**From:** John Kessler [Jkessler@energy.state.ca.us]  
**Sent:** Thursday, August 21, 2008 3:59 PM  
**To:** Tanya A. Gulesserian; Emi Kiyan; Jacob Hawkins; Jason Ricks; Negar Vahidi; Suzanne Phinney; Perry.Fontana@ausra.com; Dal Hunter; John Mckenzie; David Hacker; Beverly Bastian; Brian McCollough; Caryn Holmes; Erin Bright; Michael Doughton; Mary Dyas; Mark Hamblin; Obed Odoemelam; Sudath Arachchige; Steve Baker; Shahab Khoshmashrab; Tuan Ngo; Susan Jones; M.Lindley@pwa-ltd.com; Scott Stoller; Angela Leiba; Kristen\_E\_Walker@URSCorp.com  
**Cc:** Agena Garnett; Robin Bell; Mary and Tim Strobridge  
**Subject:** Carrizo - Cumulative Impacts Analysis Figure  
**Attachments:** Carrizo Cumulative & Bio Res Figure v2 (8-21-08).pdf

**FIGURE 1**  
Carrizo Energy Solar Farm -

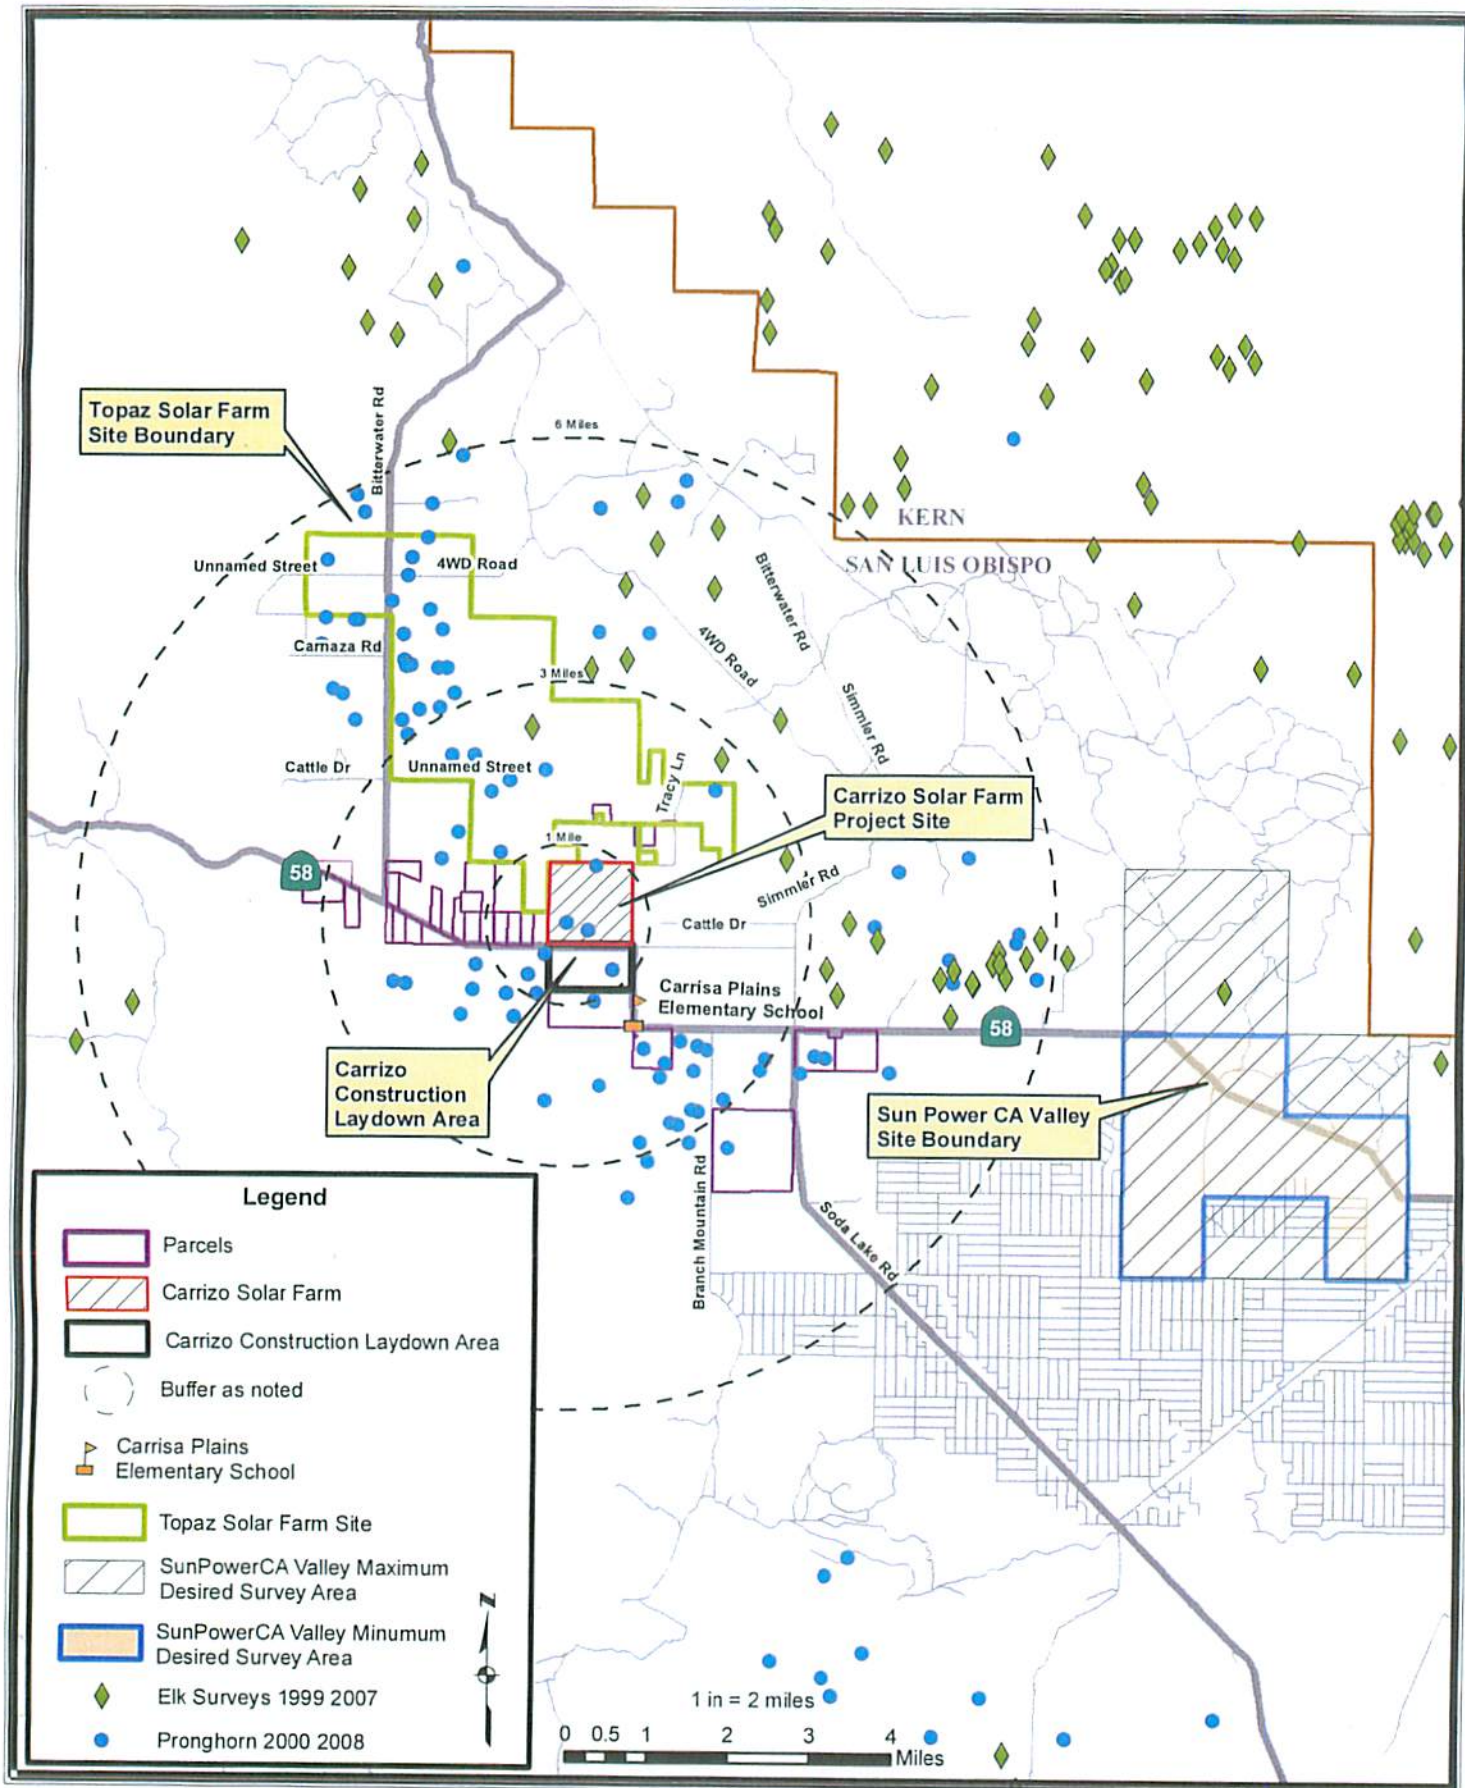
Thank you John,  
This map proves a lot of points. It leaves nothing to the imagination as to where to Antelope Corridor is.

FIGURE 1  
Carrizo Energy Solar Farm -

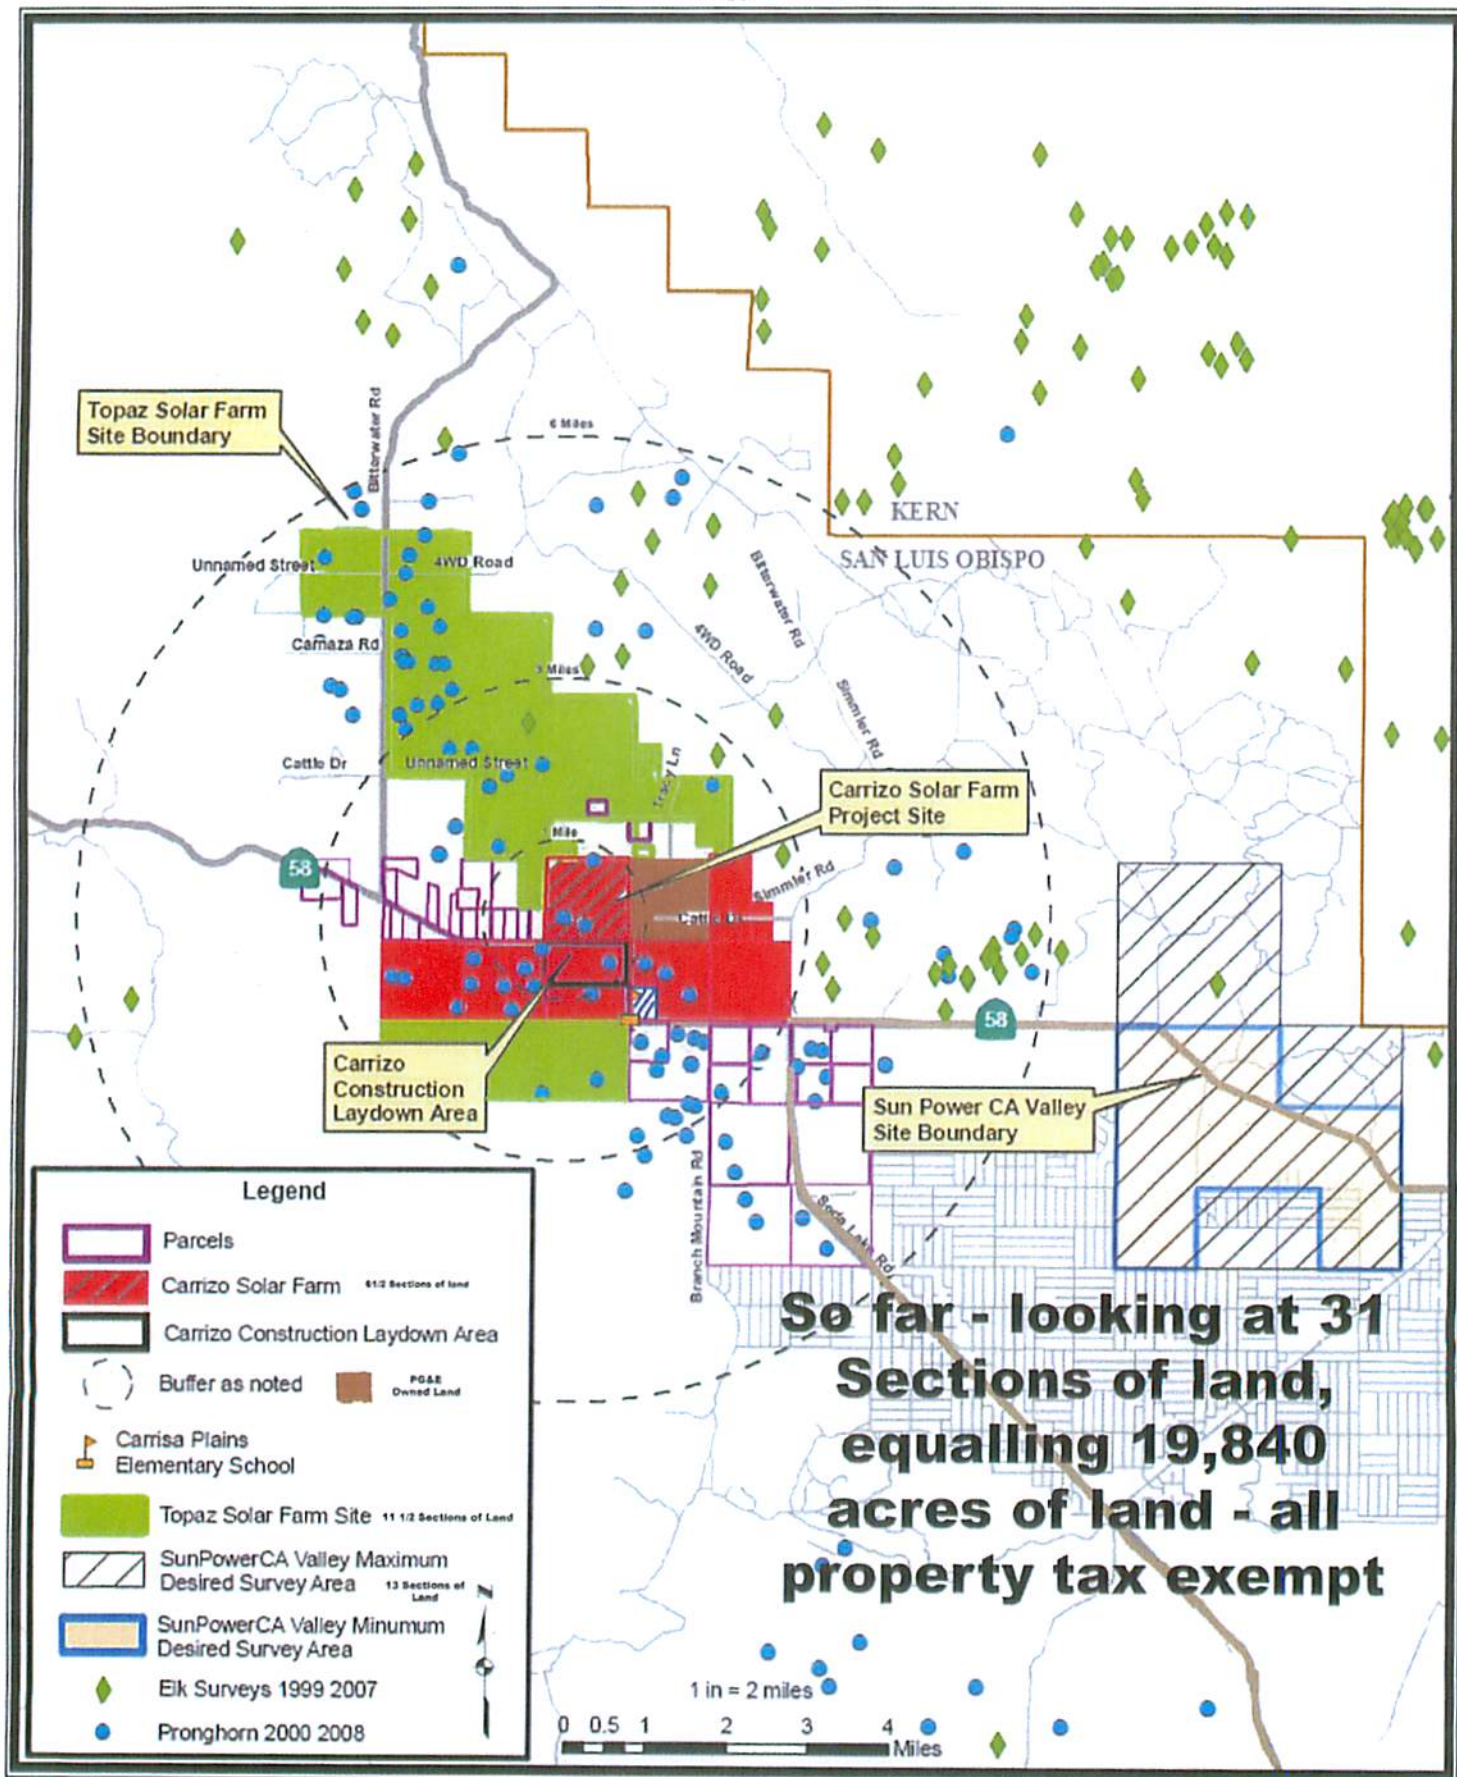
Here is a revised map. The added dots for the antelope can be proven with pictures.
